**Town of Breckenridge**  
**Planning Commission Agenda**  
Tuesday, September 20, 2011  
Breckenridge Council Chambers  
150 Ski Hill Road

PLANNING COMMISSION MEETING

Planning Commission Staff Report

# 1 Landscape Plan

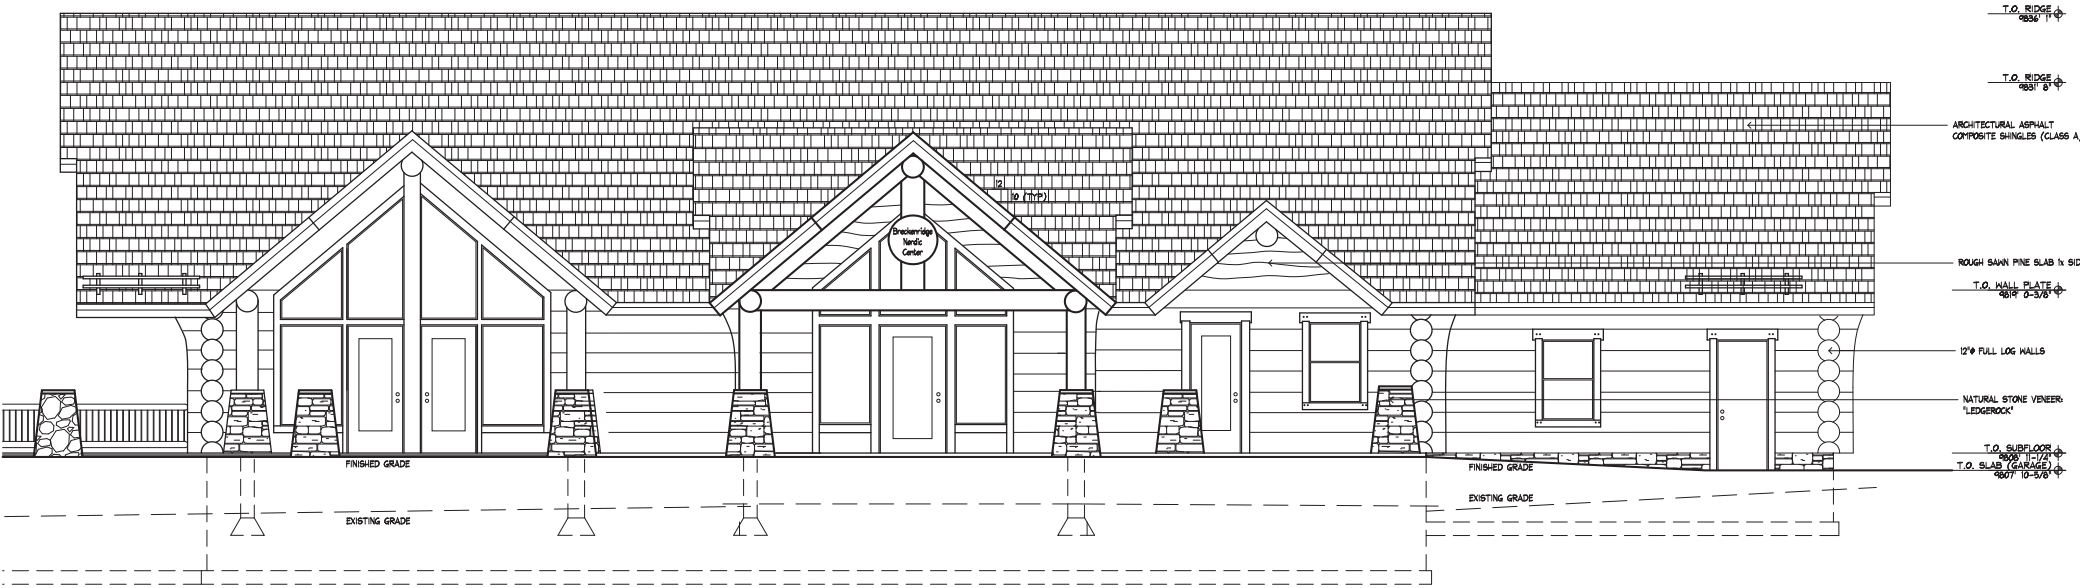
However, Staff believes that the buffering to neighboring properties could be improved. The properties to the east and west could be better buffered from the new structure and parking lot. Staff believes 12 – 14 additional spruce trees varying in size from 6’ – 10’ in height should be added to the site plan along Grandview Drive and the 50’ right-of-way to the east of the proposed parking lot. This will allow for better pedestrian level buffering. While there are significant existing tree stands much of the crowns of

**Landscaping (22/A & 22/R):** *“The town finds that it is in the public interest for all developments to maintain healthy trees and to provide landscape improvements for the purposes of: complementing the natural landscape and retaining the sense of a mountain environment; improving the general appearance of the community and enhancing its aesthetic appeal; preserving the economic base; improving the quality of life; delineating and separating use areas; increasing the safety, efficiency, and aesthetics of use areas and open space; screening and enhancing privacy; mitigating the adverse effects of climate, aspect, and elevations; conserving energy; abating erosion and stabilizing slopes; deadening sound; and preserving air and water quality.”* Furthermore, the relative section of this Policy is more specific: *“(1) At least one tree a minimum of eight feet (8') in height, or three inch (3) caliper, should be planted at least every fifteen feet (15') along all public rights of way adjacent to the property to be developed.”* Staff believes that approximately seven (7) spruce trees of 8' – 10' in height needs to be added along Grandview Drive and another six (6) or seven (7) evergreen trees should be added along the 50' right-of-way to the east of the proposed parking lot to better screen the proposed parking lot. Evergreen trees are suggested because they provide screening in winter. Also, moving some of the proposed landscaping to better locations on the site would help with screening. Staff welcomes Planning Commission input on the proposed landscaping.

1. Does the Planning Commission agree that negative one (-1) point should be assessed for a long, unbroken ridgeline?
2. Does the Commission agree that additional landscaping is needed along the Grandview Drive and Ski Hill Road rights-of-way?
3. We welcome any of general feedback.

2 South Elevation  
 1/4" = 1'-0"

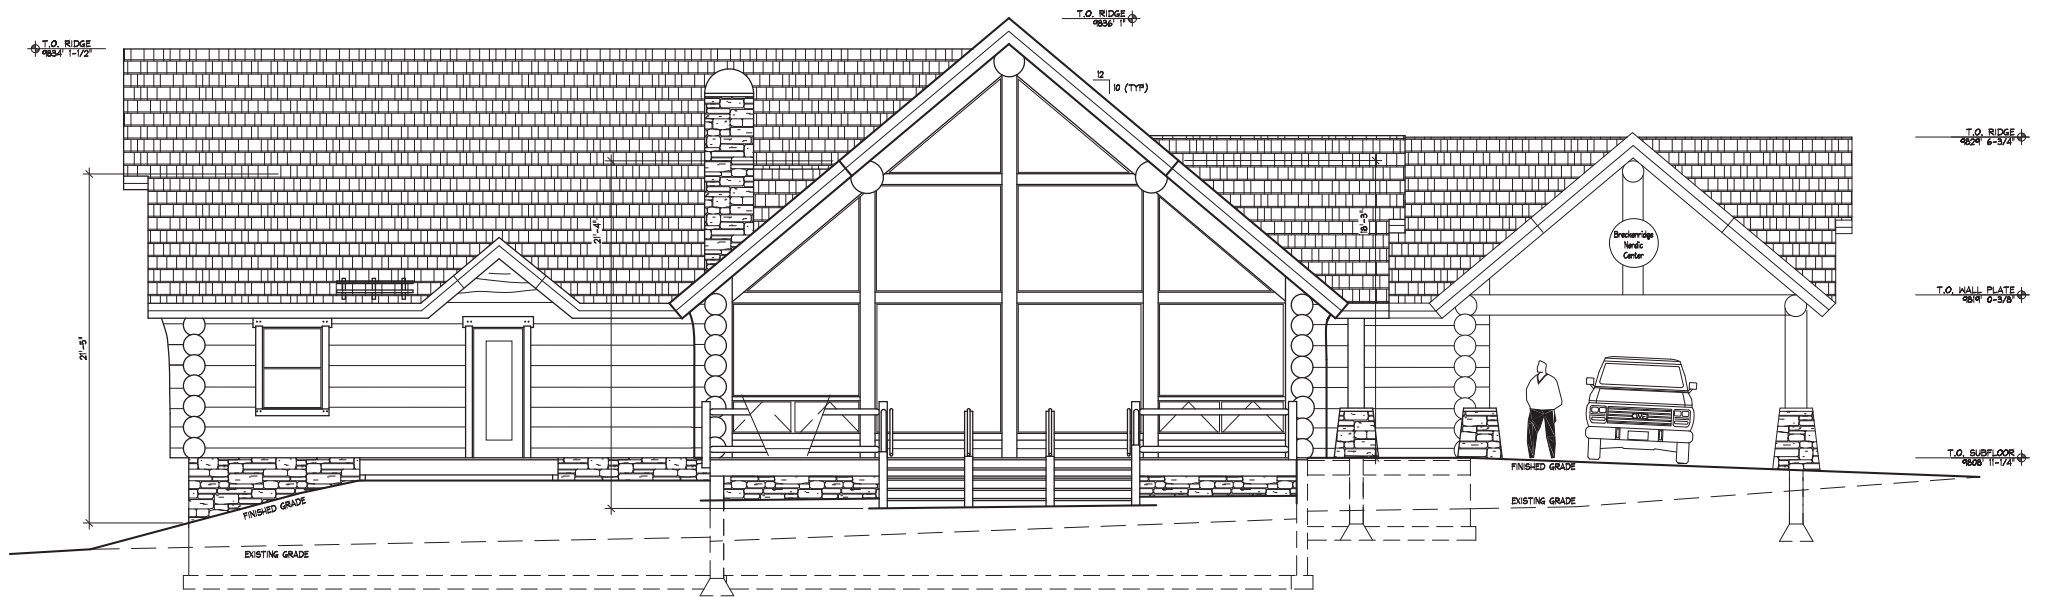
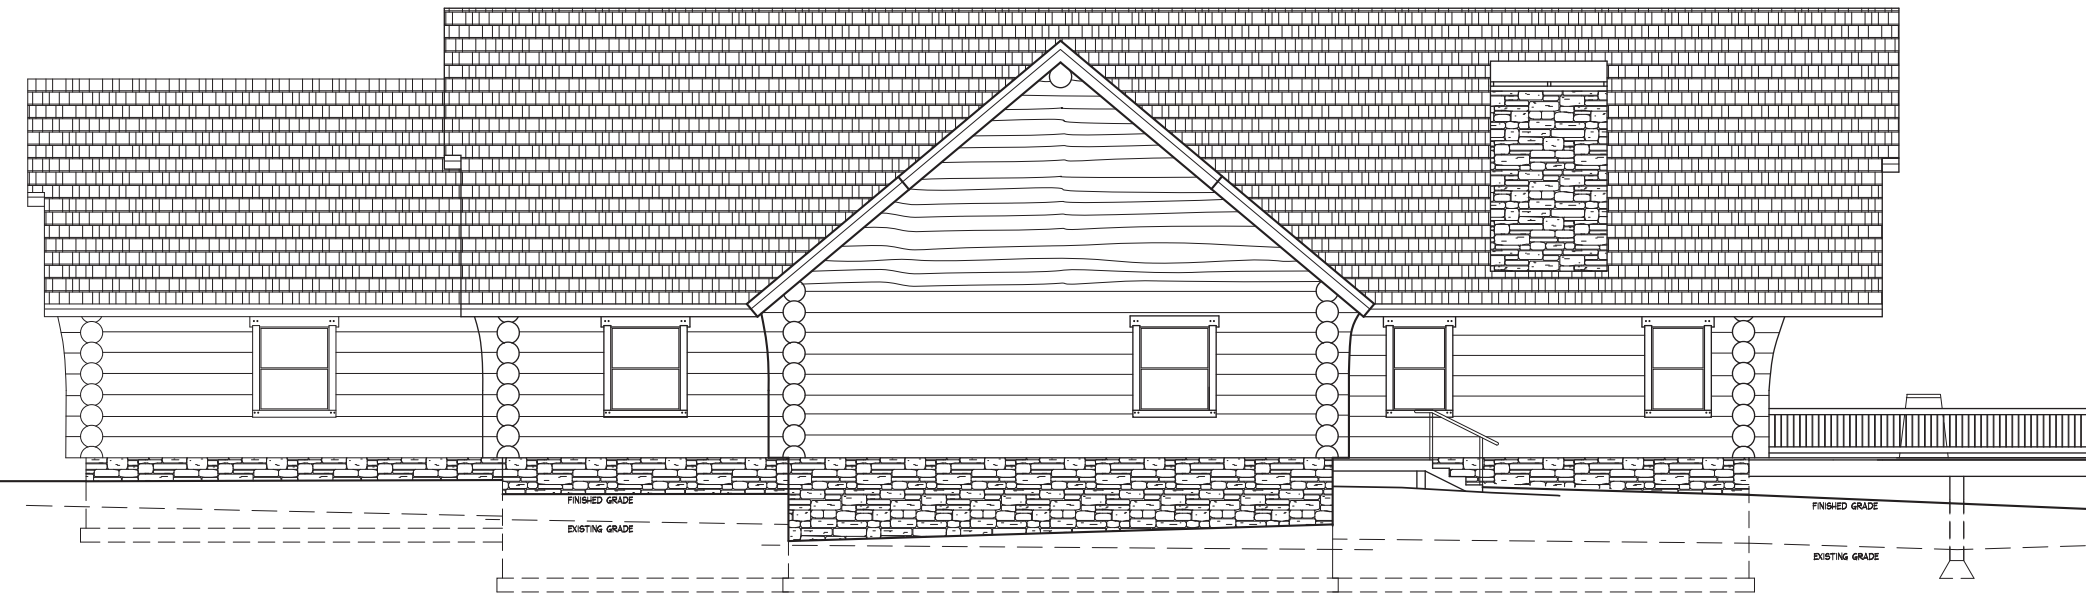
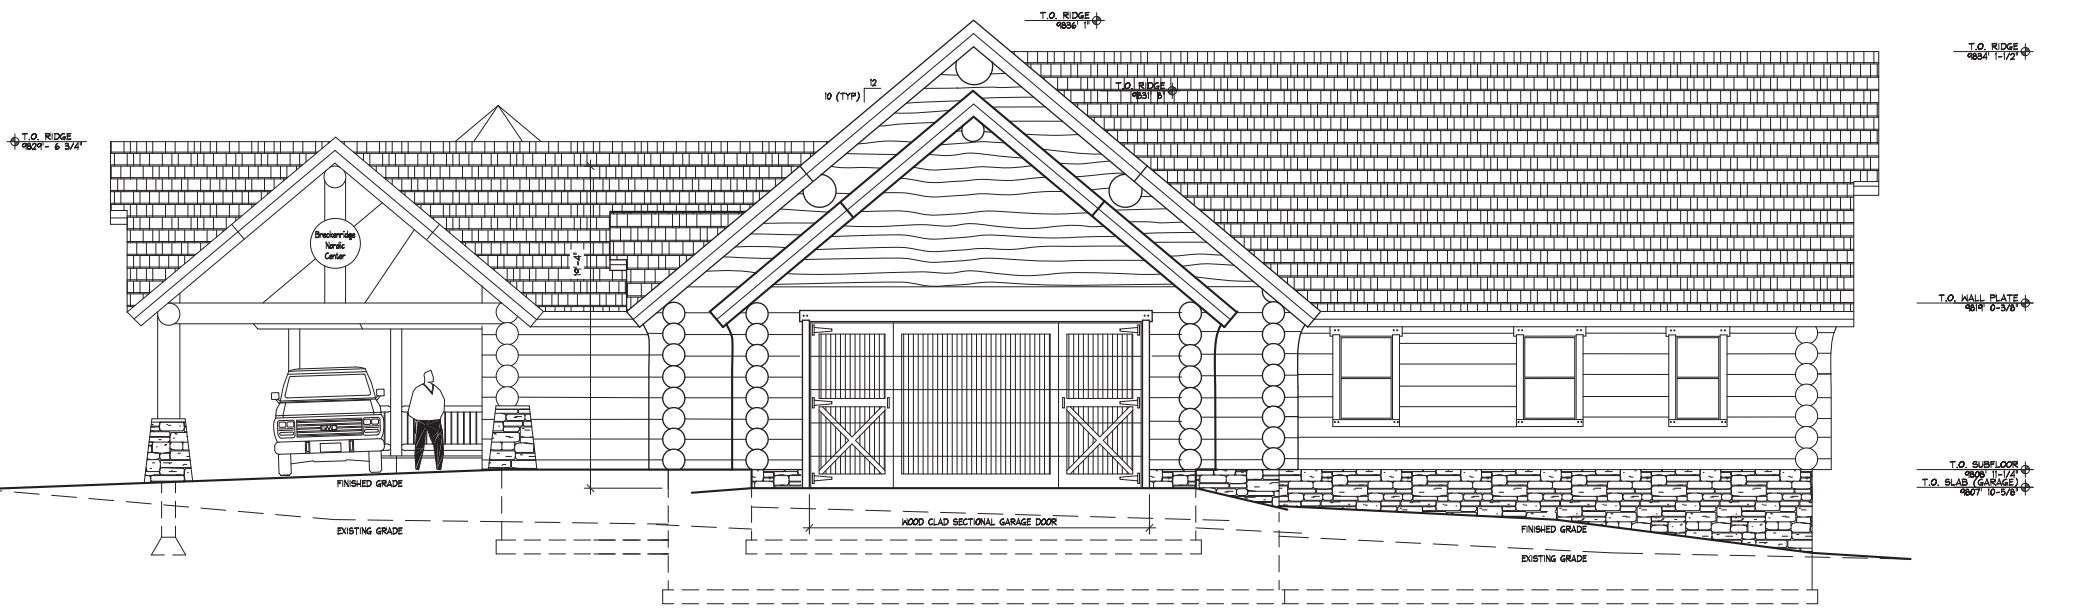
There is one issue related to this policy. Buildings are encouraged to provide broken, interesting roof forms that step down at the edges. Long, unbroken ridgelines, fifty feet (50’) or longer, are discouraged. The roof line on the proposed structure is 87’ long, hence this current design warrants negative one (-1) point for the length of the unbroken ridgeline.

**Site Plan**  
 Scale 1/8" = 1'-0"

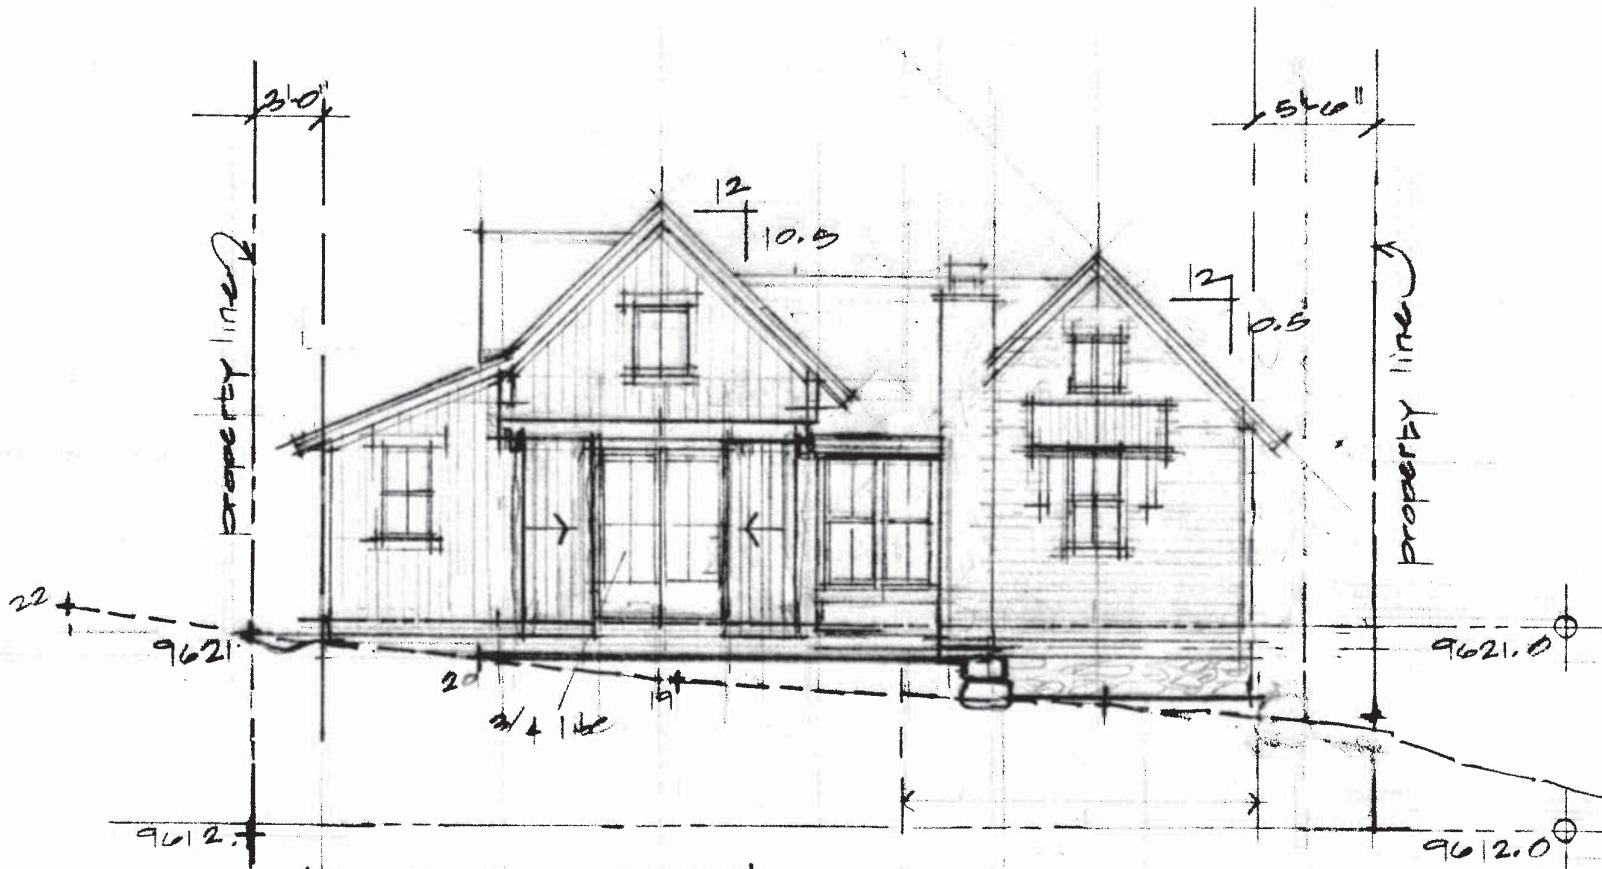
The drawings show that the eaves and the chimney of the new addition are encroaching into the east setback and the eaves are encroaching on the south setback. Does the Commission support allowing these encroachments?

The driveway and courtyard are planned to be surfaced in stone pavers spaced such that grass or moss can grow between the pavers. This will give the appearance of a yard while providing access. Staff understands that this can only function this way if the grass is maintained. We are suggesting a landscaping covenant that would include this provision. Does the Commission concur?

GILLER RESIDENCE  
 EAST ELEVATION  
 1/8" = 1'-0" 9.6.11

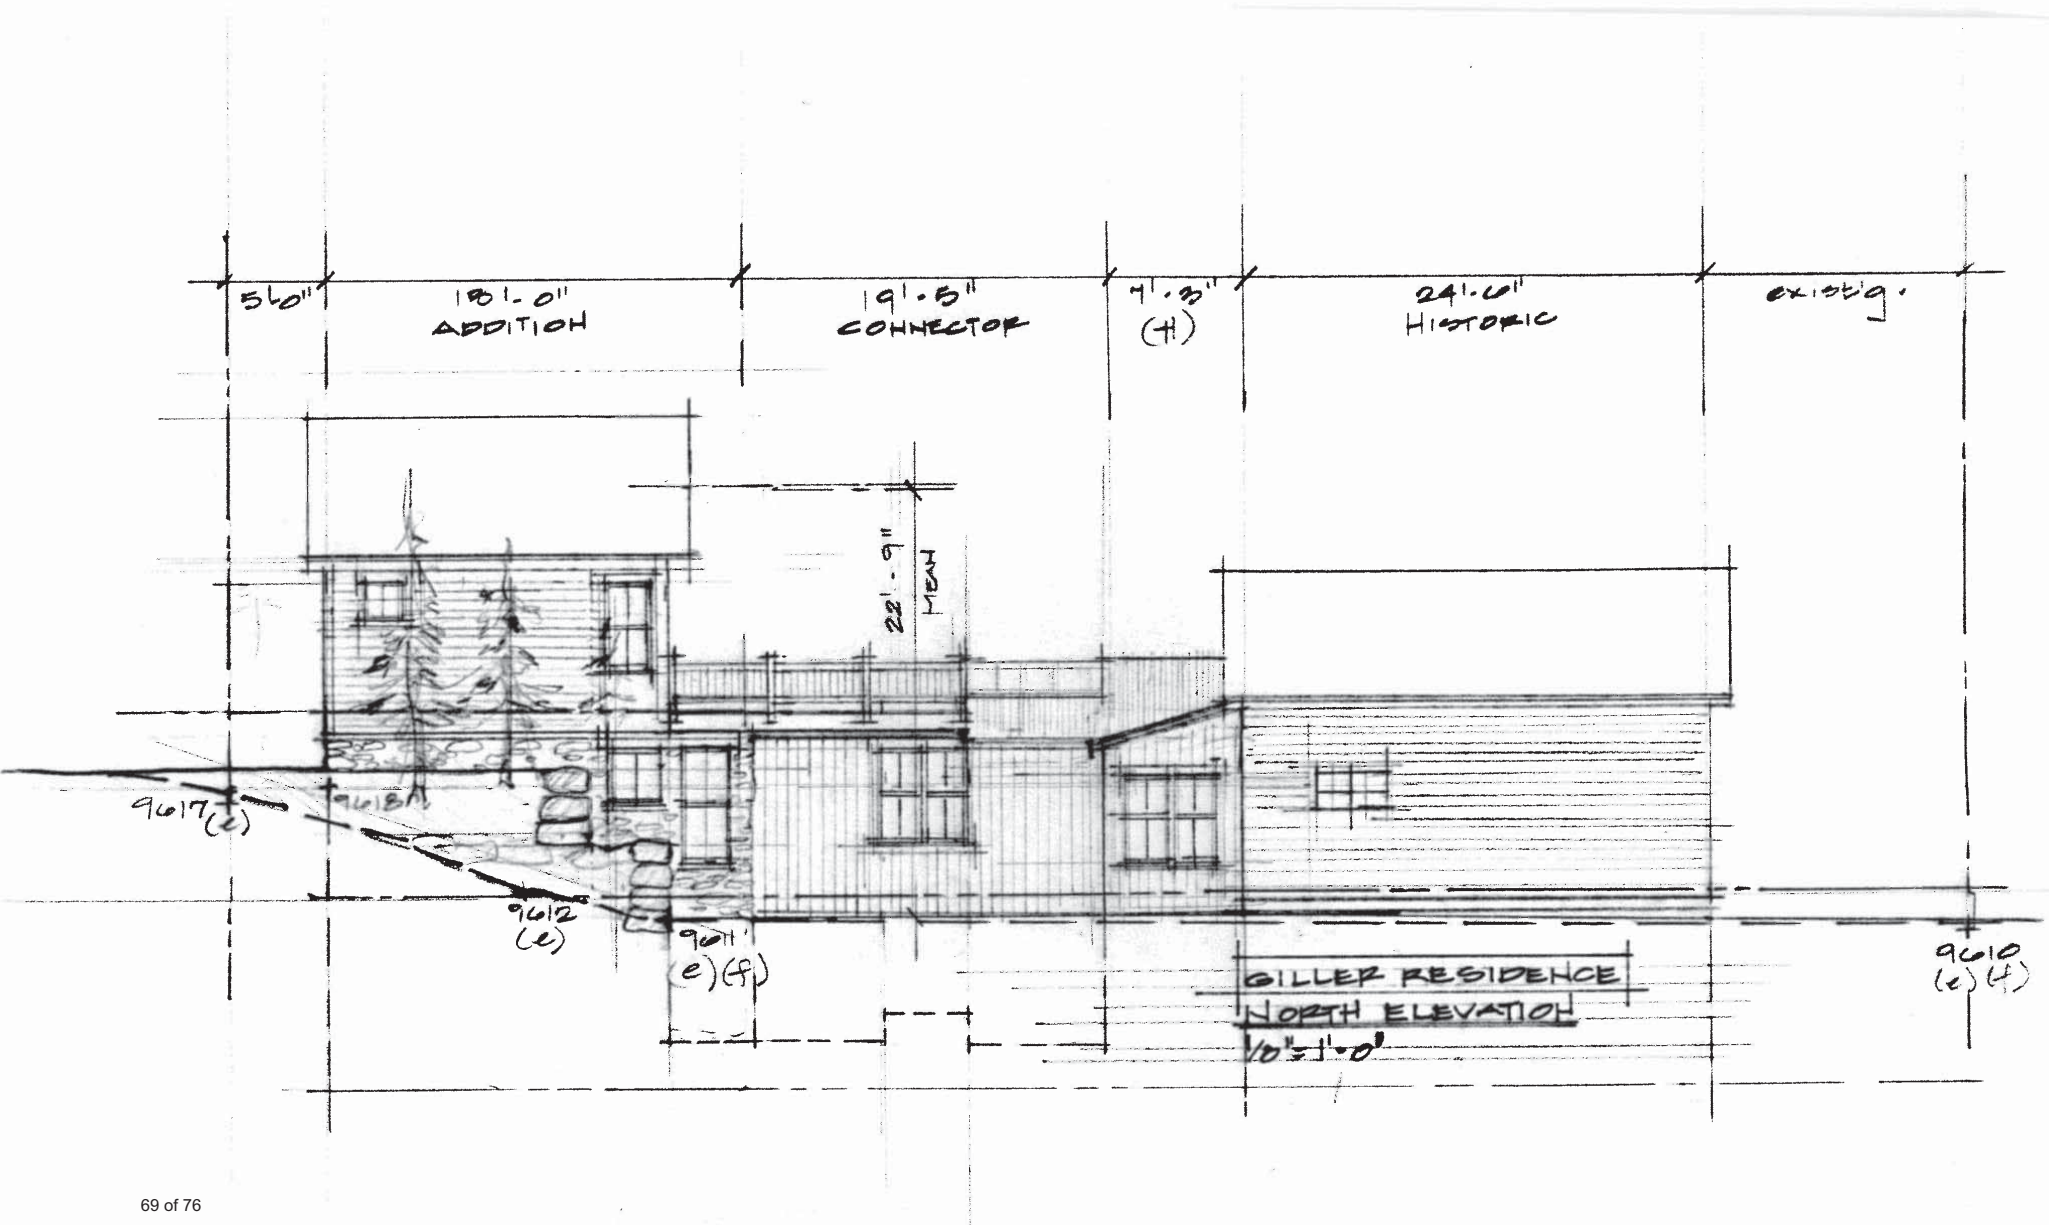
The east elevation (alley side) utilizes simple gable forms and broken massing. A pair of French doors is shown with sliding barn-door covers (similar to those seen on the historic Fuqua Livery Stable in the Arts District). Staff has no concerns.

The exposed concrete portions of the lower floor of the new addition will be created with concrete form-liners that will replicate a horizontal or vertical wood pattern similar to the Exchange Lot Parking structure. Ideally, this surface should be faced with wood siding or a fiber cement siding appearing as wood. We welcome Commissioner comment.
